Title - Sujet Resurfacement de la route et autres t	
Solicitation No. - N° de l'invitation EZ899-151714/A	Amendment No. - N° modif. 003
Client Reference No. - N° de référence du client	Date 2015-02-13
GETS Reference No. - N° de référence de SEAG PW-\$PWY-015-7426	
File No. - N° de dossier PWY-4-37255 (015)	CCC No./N° CCC - FMS No./N° VME
Solicitation Closes - L'invitation prend fin at - à 02:00 PM on - le 2015-02-25	Time Zone Fuseau horaire Pacific Standard Time PST
F.O.B. - F.A.B. Plant-Usine: <input type="checkbox"/> Destination: <input checked="" type="checkbox"/> Other-Autre: <input type="checkbox"/>	
Address Enquiries to: - Adresser toutes questions à: Chan (PWY), Scarlett	Buyer Id - Id de l'acheteur pwy015
Telephone No. - N° de téléphone (604) 775-9382 ()	FAX No. - N° de FAX (604) 775-6633
Destination - of Goods, Services, and Construction: Destination - des biens, services et construction: Parks Canada - Pacific Rim National Park - Tofino, BC

Public Works &
Government Services Canada
Highway Resurfacing & Other Work, Hwy #4,
Km. 0.000 to km. 21.500
Through Pacific Rim National Park
Project No. R.067785.001

ADDENDUM No. 3

Highway 4 Resurfacing Project - Culvert Location Map

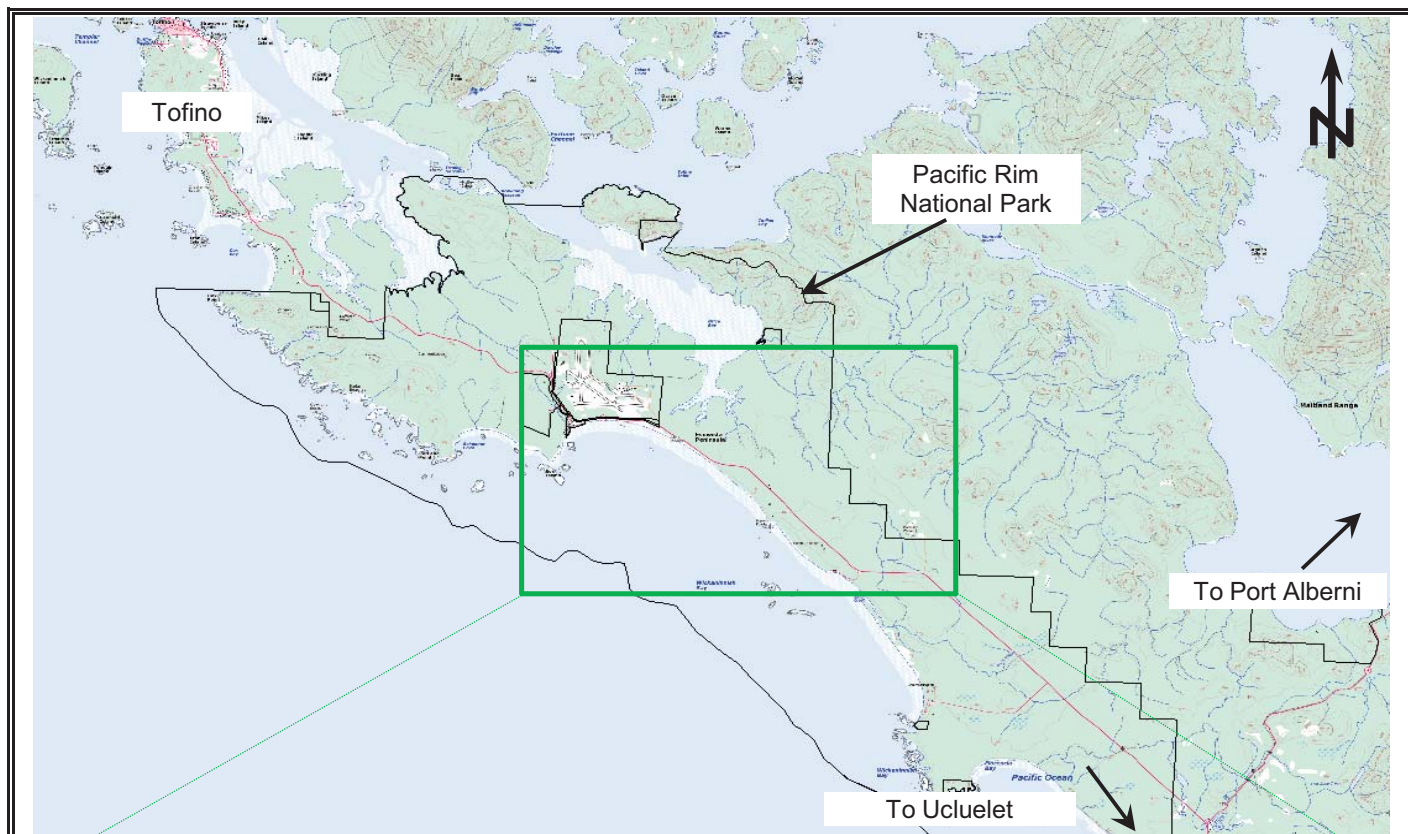
- Q1. At Station 13+580, 13+860 & 16+110 it is hard to determine the exact location of the pipes to be replaced. Can the culvert be marked with a survey stake and ribbon?
- A1. The five culverts included in the tender have been marked on site with a stake flagged with blue and pink ribbon. Each stake is located over the culvert adjacent to the northbound lane. The culvert locations can further be located using the coordinates listed below, and the attached map.

Station (km)	Latitude	Longitude
16+110	49.07282	-125.777
15+660	49.07309	-125.771
13+860	49.06882	-125.748
13+580	49.06719	-125.745
9+430	49.04587	-125.700
